Access Compliance Report

Public Rights-of-Way

(Curb Ramps)

Intersection ID: 20624	Main Street: BRAMBLEWOOD_DR	Cross Street: W_ARROWWOOD_RD	Location: NW
ADA ID: 06933AB97EA6	Ramp Type: PerpDiag	Initial Pass/Fail: Pass	Overall Compliance: No
			Severity Score: 10.25

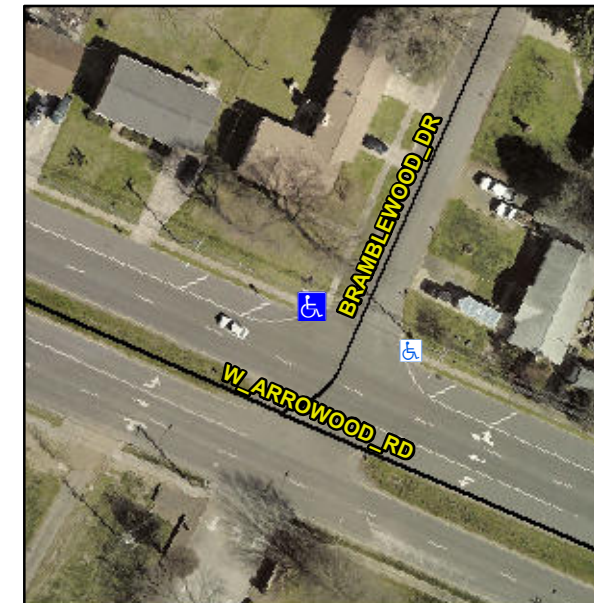
Not Found, R304.5.3, R304.2.1, R304.2.2-Perp, R304.3.2-Para

Compliance	Description	Data	Compliance	Description	Data
N/A	Ramp Length (in)	64.5	Yes	Ramp Slope (%)	5.2
Yes	Ramp Width (in)	48.0	No	Ramp XSlope (%)	3.5
N/A	Flare Type LT	Sloped	N/A	Flare Type RT	N/A
N/A	Flare Slope LT (%)	1.2	Yes	Flare Slope RT (%)	4.9
N/A	Flare Traversable LT?	Yes	N/A	Flare Traversable RT?	Yes
No	Landing Length (in)	N/A	Yes	DWS Provided?	Yes
No	Landing Width (in)	N/A	Yes	DWS Contrast?	Yes
No	Landing Slope (%)	N/A	Yes	DWS Length (in)	24.0
No	Landing X Slope (%)	N/A	Yes	DWS Full Width?	Yes
N/A	Landing Curb? (Y/N)	No	Yes	DWS Offset (in)	0.0
N/A	Shared Landing?	No			
Yes	Gutter Ponding?	No	Yes	Gutter Slope (%)	2.2
Yes	Gutter Lip Ht (in)	0.0	No	Gutter X Slope (%)	3.7
N/A	Painted X Walk1?	No	N/A	Painted X Walk2?	No
	X Walk 1 Direction	To SW		X Walk 2 Direction	To SE
N/A	X Walk 1 Width (in)	N/A	N/A	X Walk 2 Width (in)	N/A
	X Walk 1 Slope (%)	5.7		X Walk 2 Slope (%)	6.2
	X Walk 1 X Slope (%)	6.3		X Walk 2 X Slope (%)	0.8

Remove & Replace Curb Ramp With Two New Directional Ramps or Equivalent. Remove & Replace Gutter.
